CIVIL CONSTRUCTION PLANS FOR TINKER FEDERAL CREDIT UNION

LOT 3, BLOCK 1, PEAK BROKEN ARROW ADDITION

THE CITY OF BROKEN ARROW TULSA COUNTY, OKLAHOMA

COBA PROJ. NO. PT-002460-2025

SHEET TITLE:
COVER SHEET

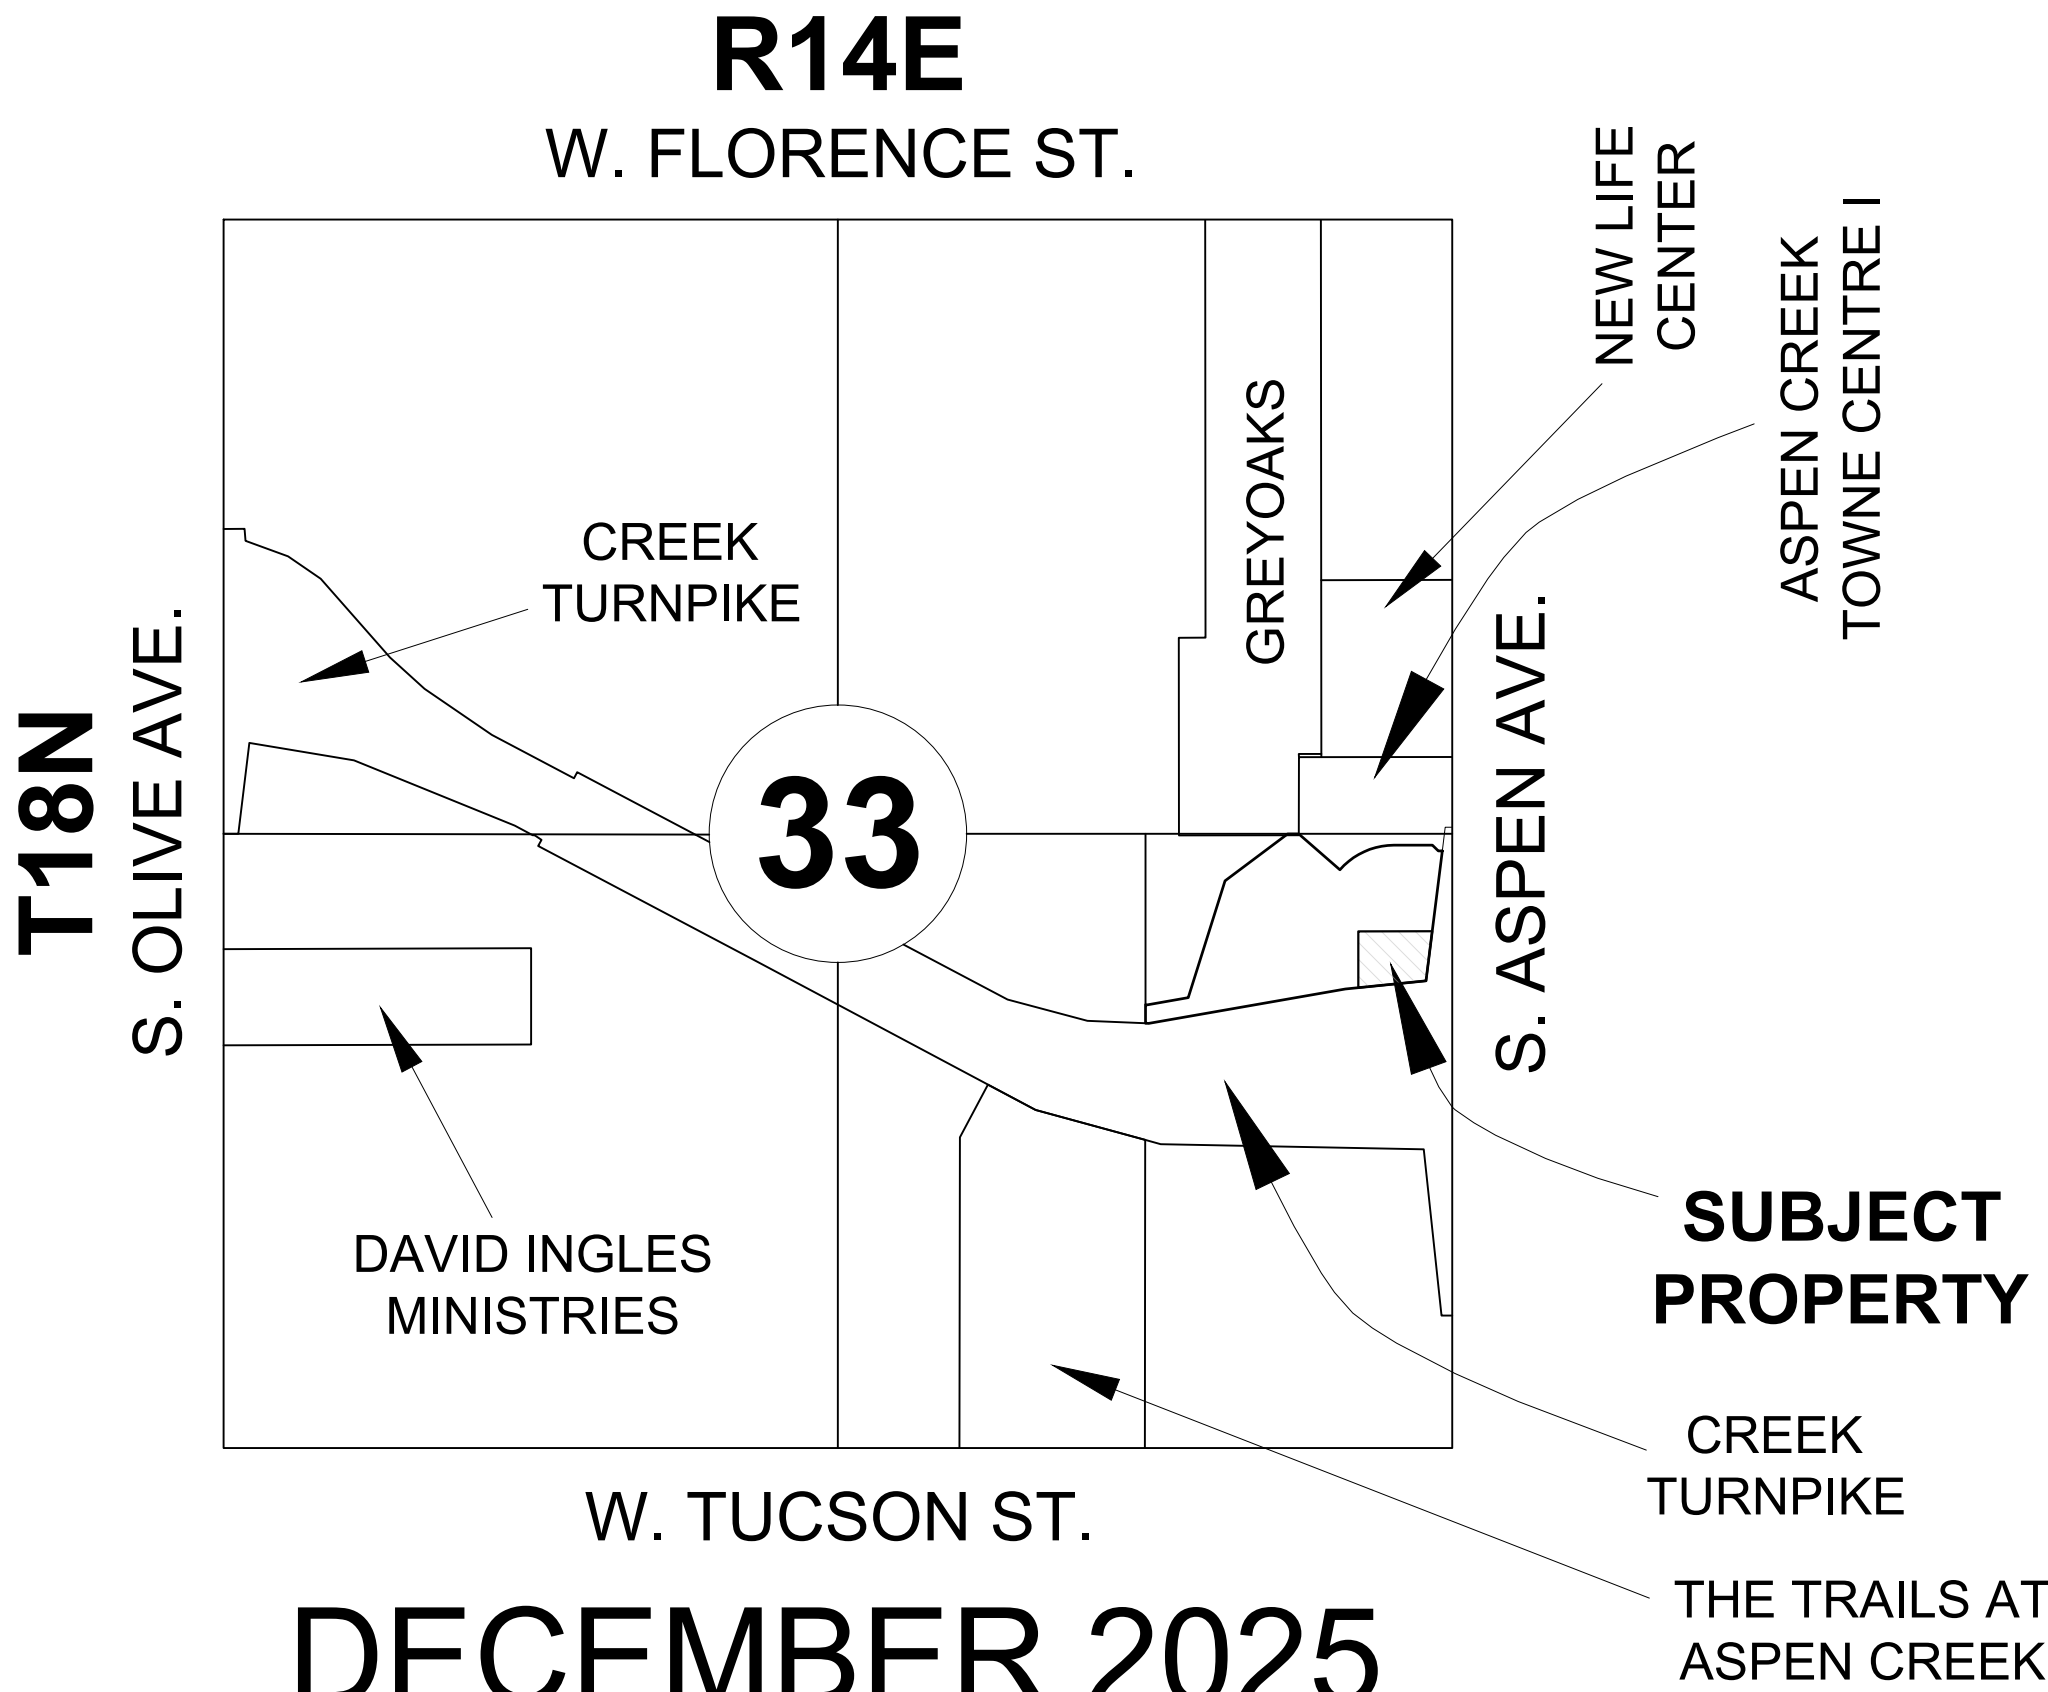
P01: Parking
variance granted
administratively via
email on 11/13/2025.
Please include copy
of email in final
submission

2 EAST ELEVATION
A-201 SCALE: 1/4" = 1'-0"

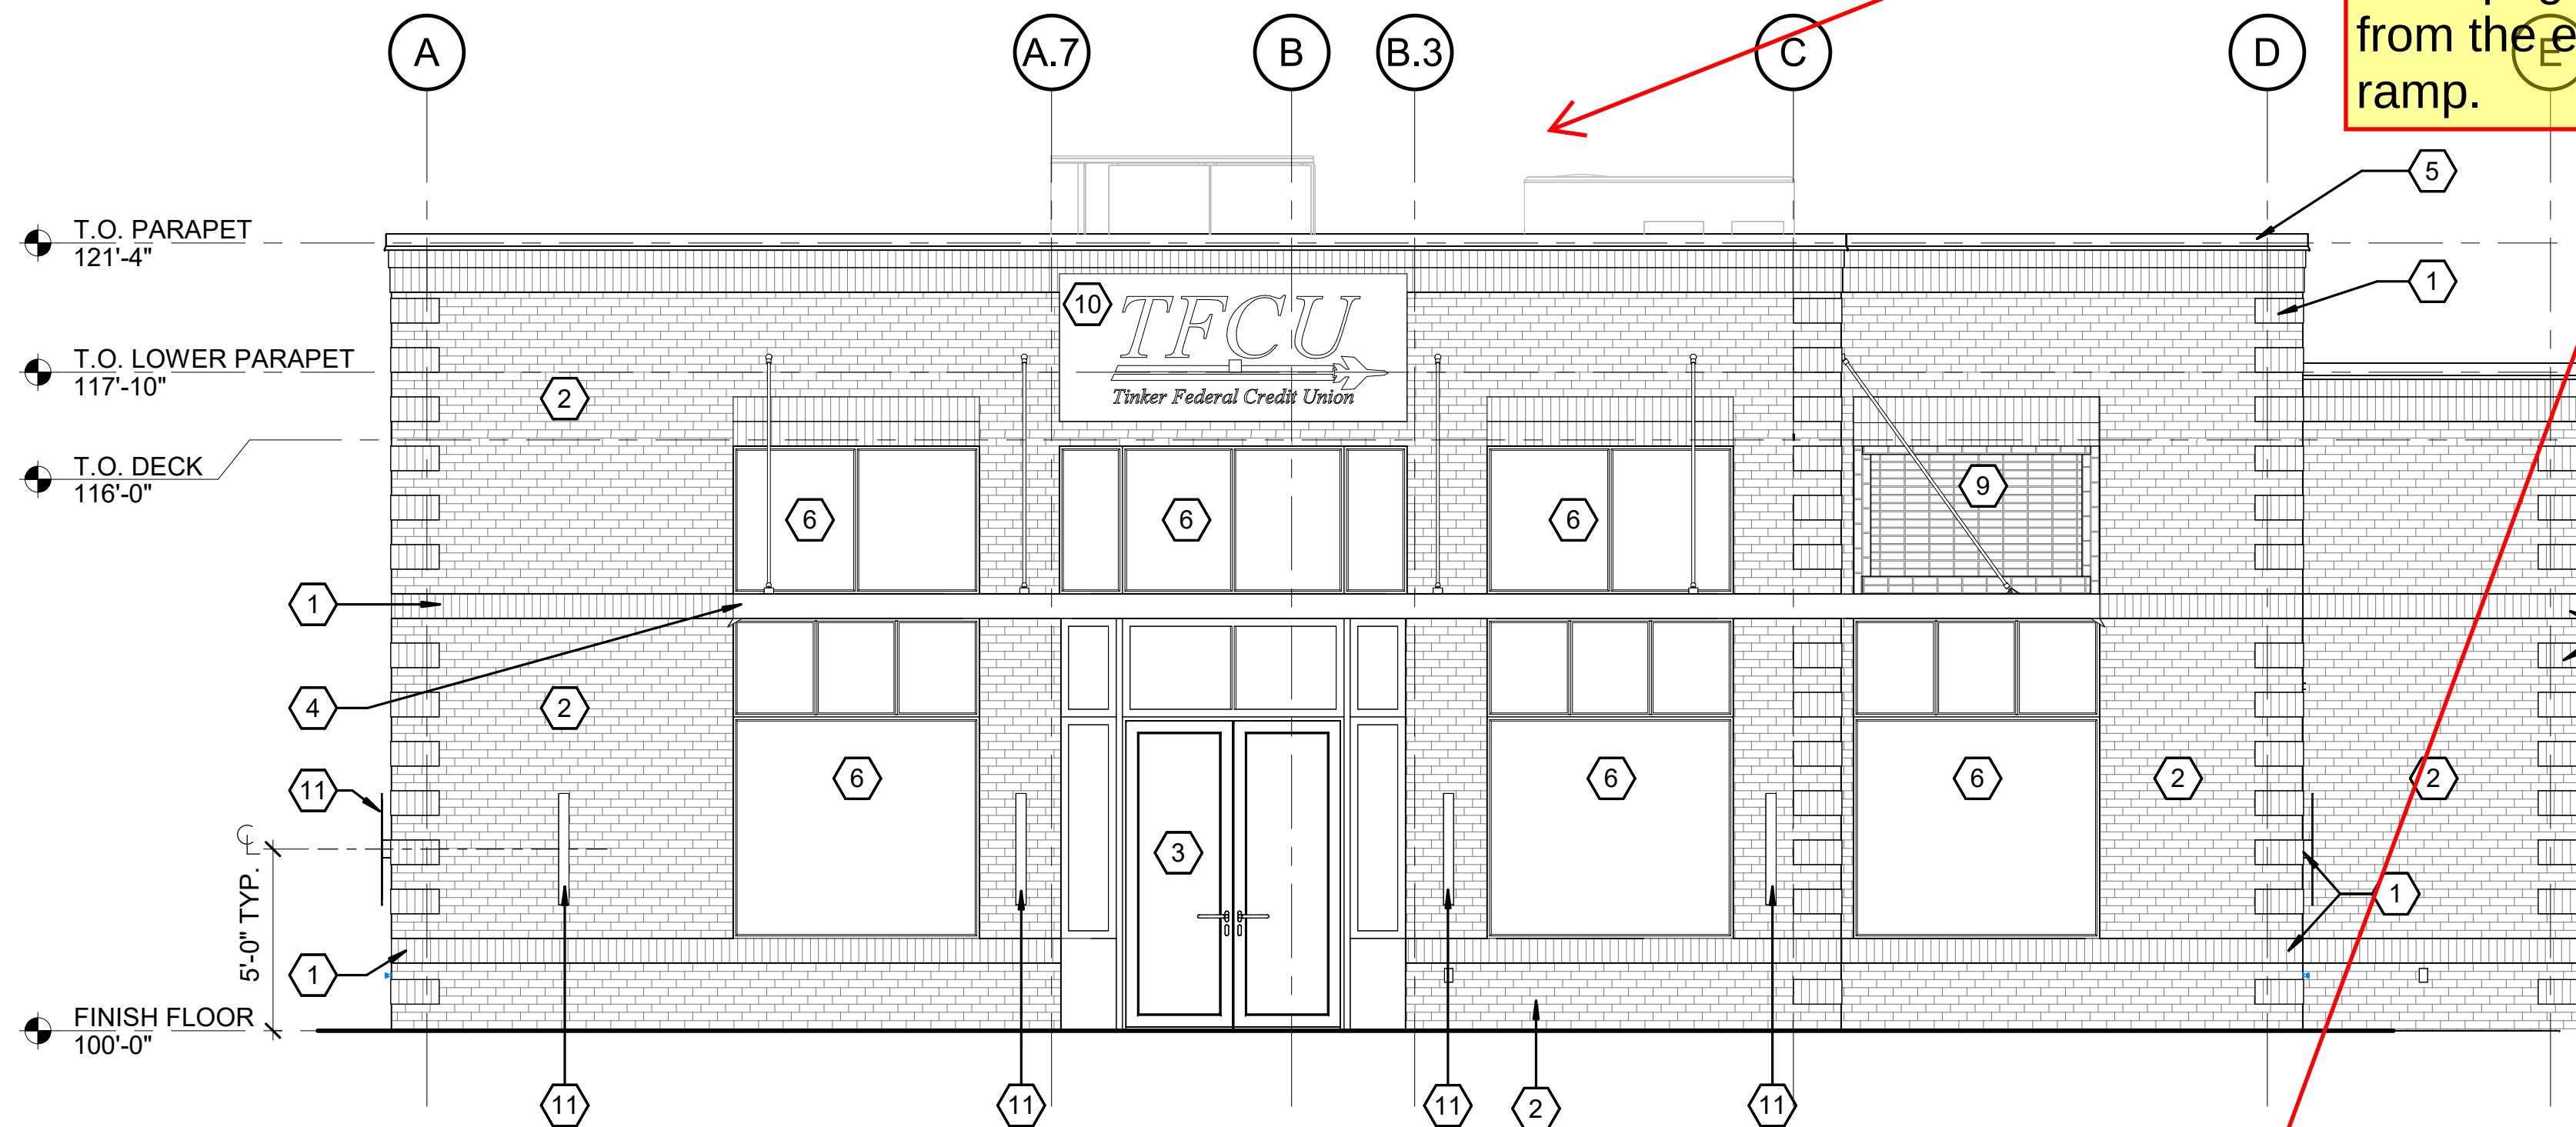
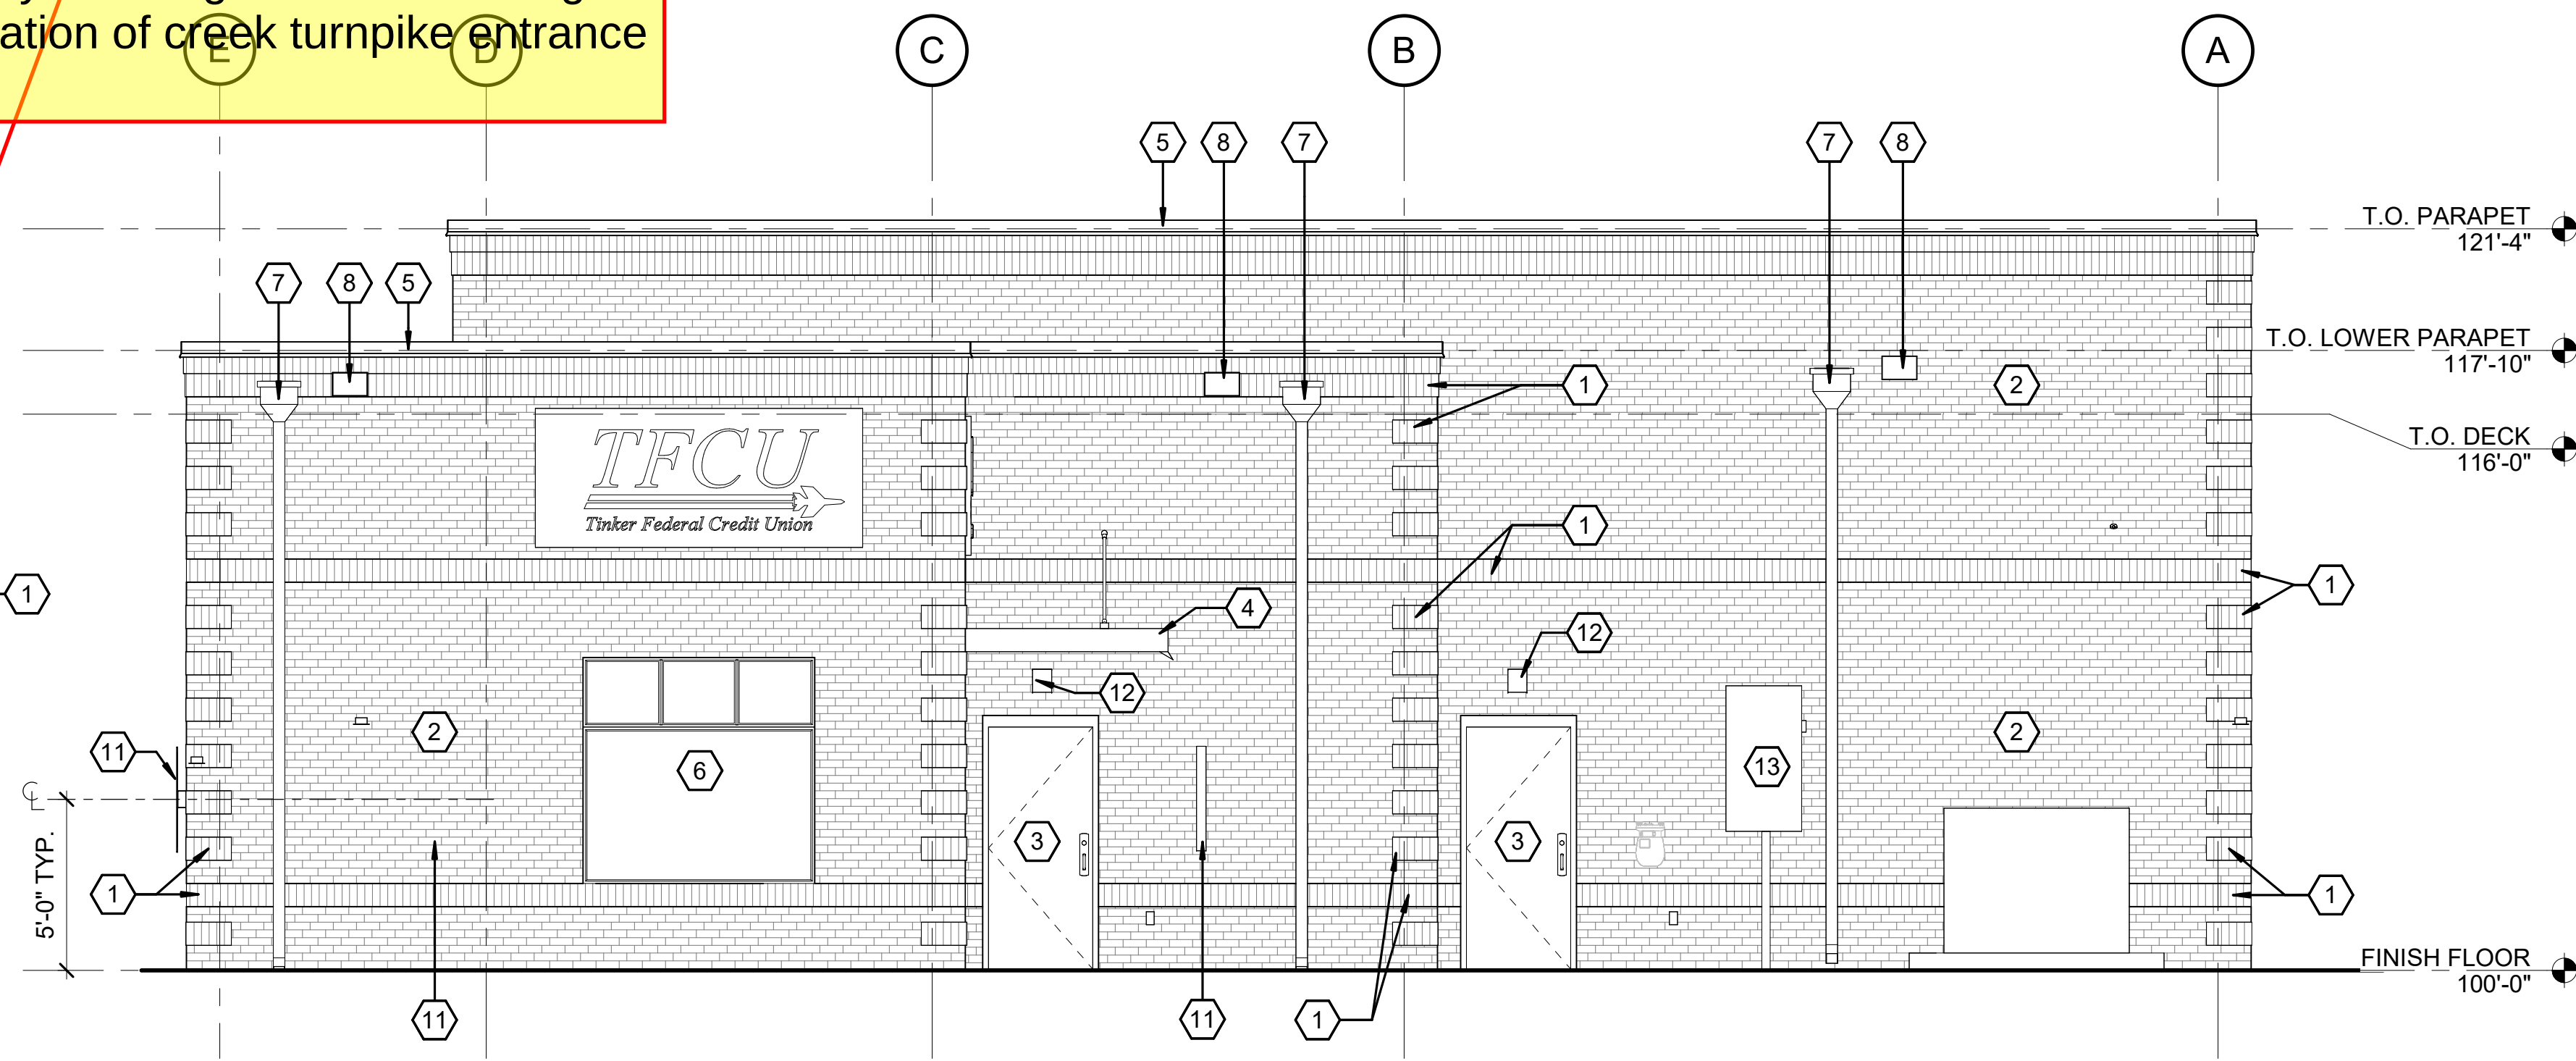
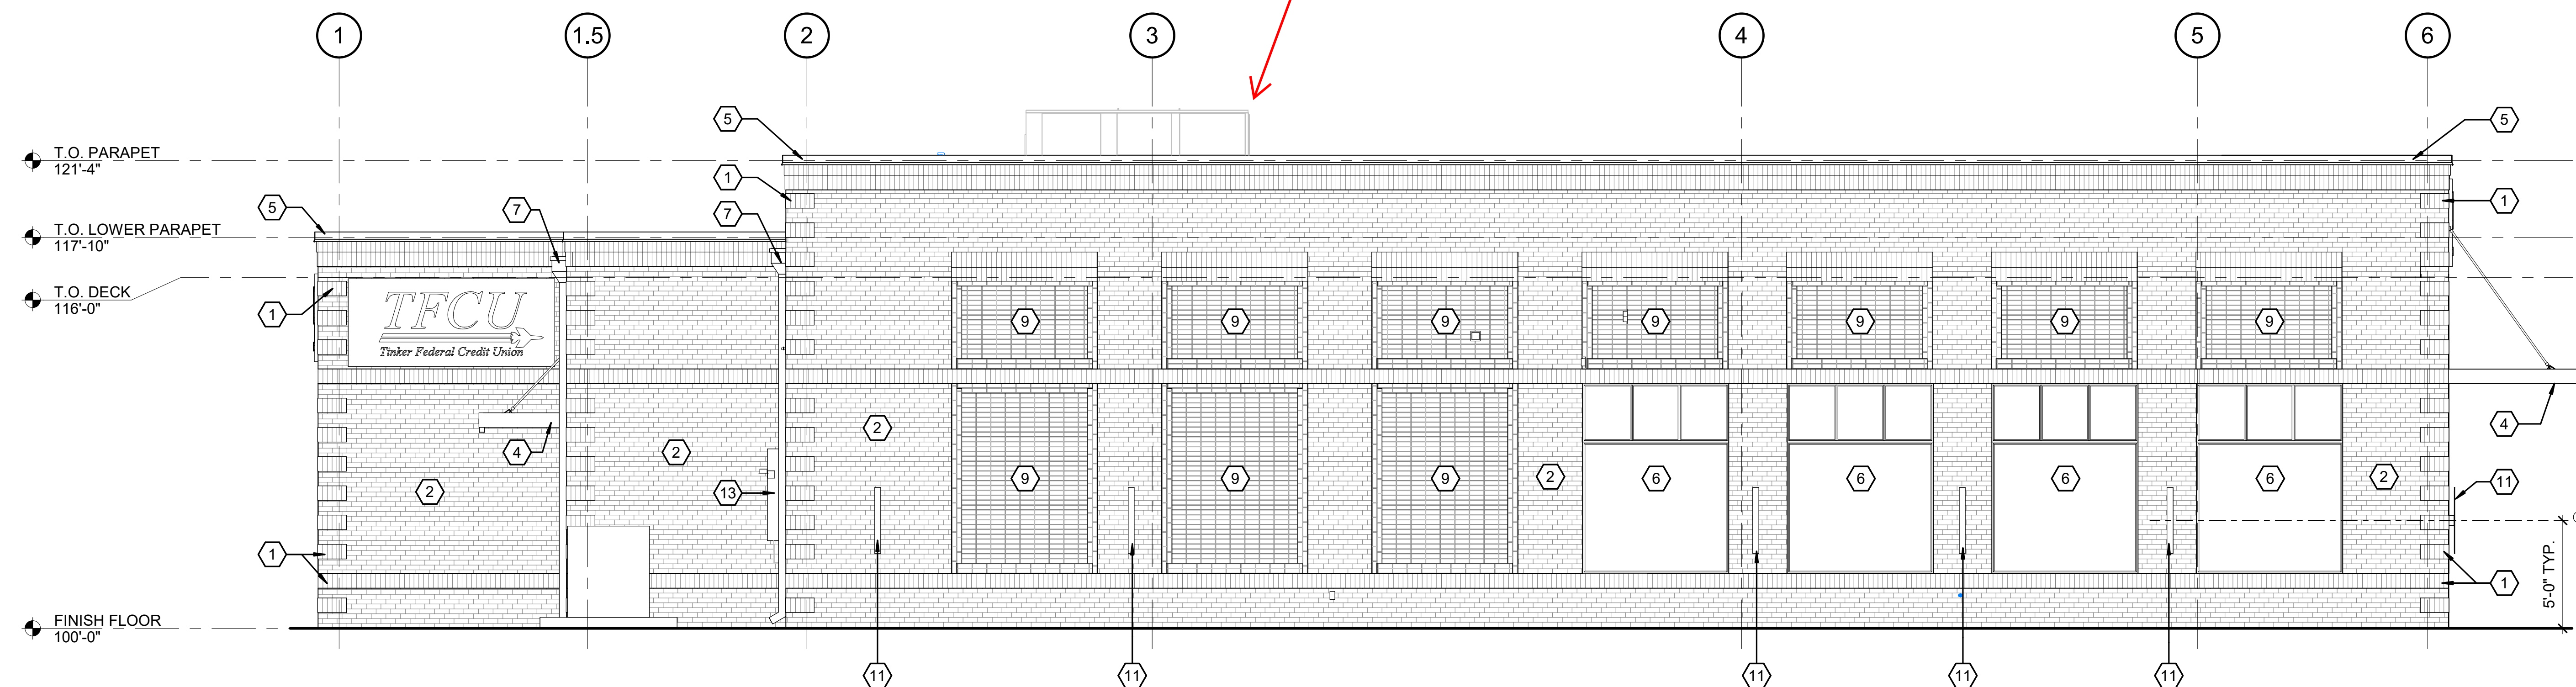
P02: HVAC screening required. Screening must match height of HVAC/mechanical units.
Screening may come up during BOA meeting for orientation. I understand there are topography challenges with screening from the elevation of creek turnpike entrance ramp.
